**Re: Cover System Corrective Measures Work Plan – Revision 1
Mott Haven Campus – X790
730 Concourse Village West
Bronx, New York
SCA LLW# 033485, Job#34857**

Re: Site Management (SM) Corrective Measures Work Plan (CMWP)
Former Metro North Property
Bronx County, Site No.: C203030

The Department has reviewed your Periodic Review Report and Corrective Measures Work Plan (CMWP), dated March 20, 2012, and has the following comments.

1 EXISTING PLUMBING UNDER X156 PODIUM PLAN - FOR REFERENCE ONLY
P503 SCALE 1/16" = 1'-0"

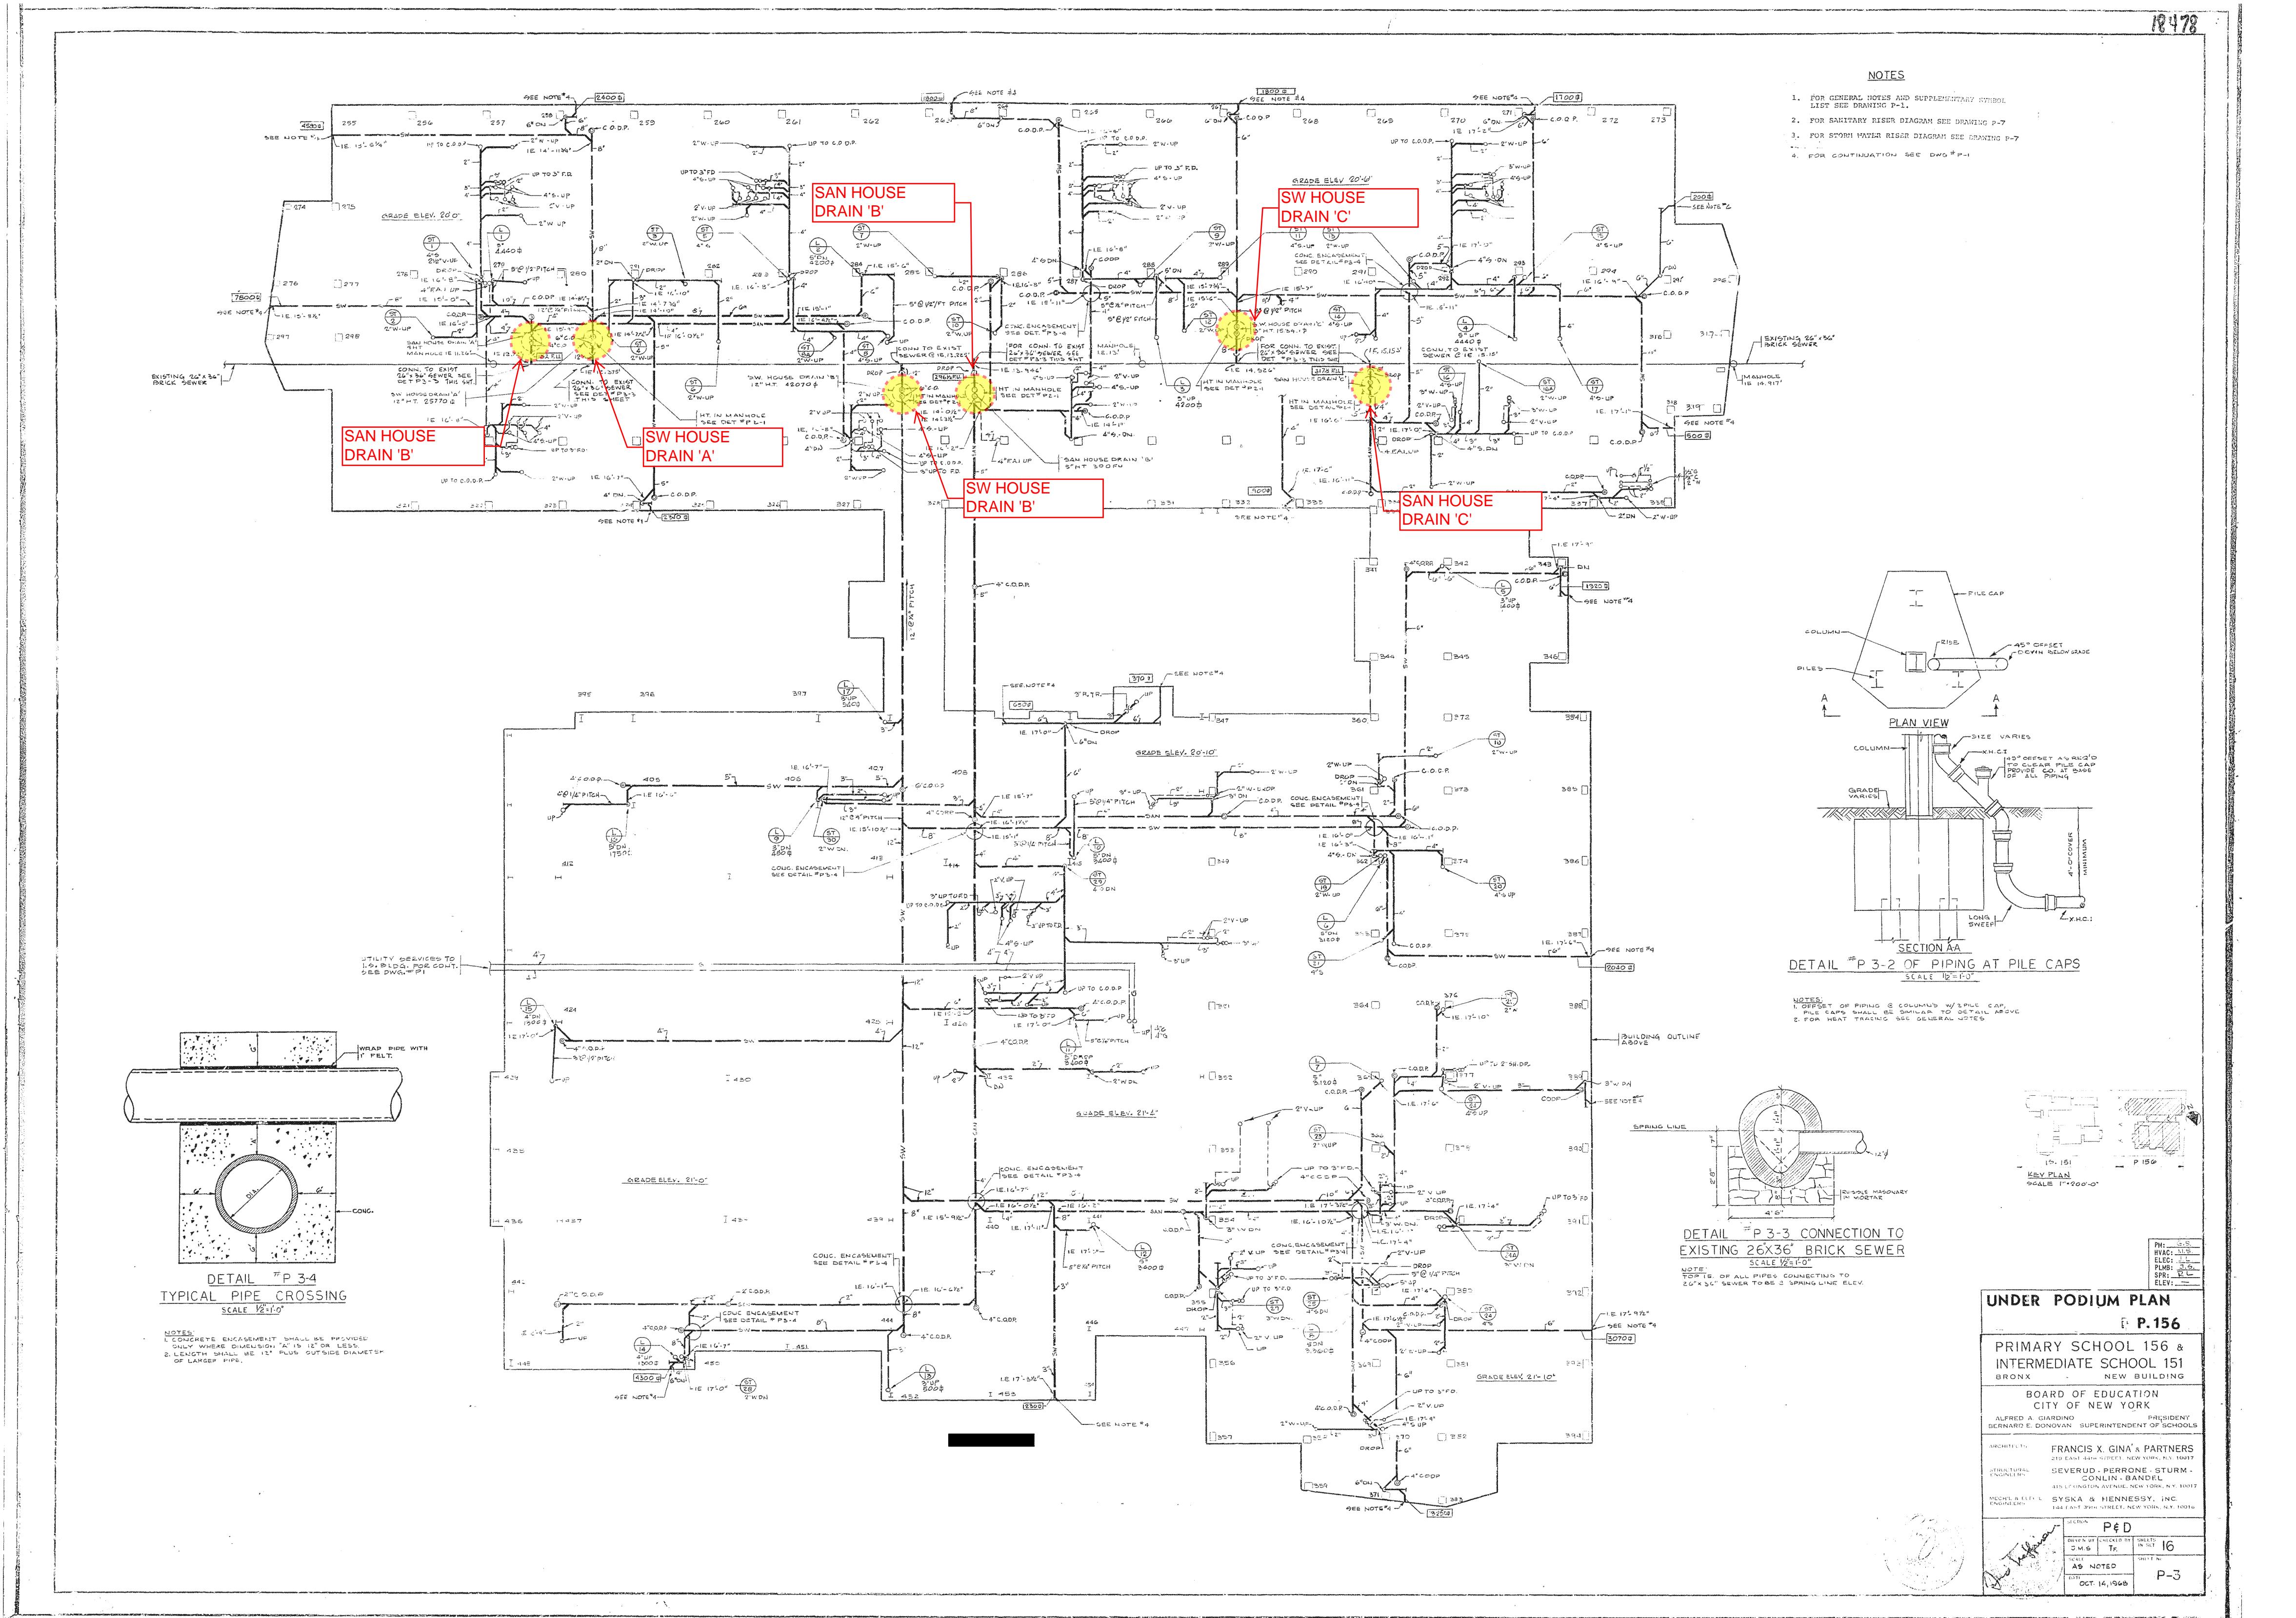
- The dedicated water truck seems excessive based upon Photo #12 in the Periodic Review Report (PRR) dated March 20, 2012. Please provide a diagram showing the full extent of the proposed sewer trench and recommend appropriate dust suppression (which may in fact be a water truck).

The duration of the remaining school plumbing system upgrade work is expected to be approximately 4 months from start to completion. This work includes exposing up to 11 house traps, video taping the connections, connecting aboveground piping to the traps, and backfilling and restoring the concrete cap. Approximately 70 cubic yards of additional excavated material (i.e., concrete cap, gravel, and soil) is anticipated to be generated during this work. A drawing showing the locations of the house traps is provided as *Attachment B* to this Work Plan.
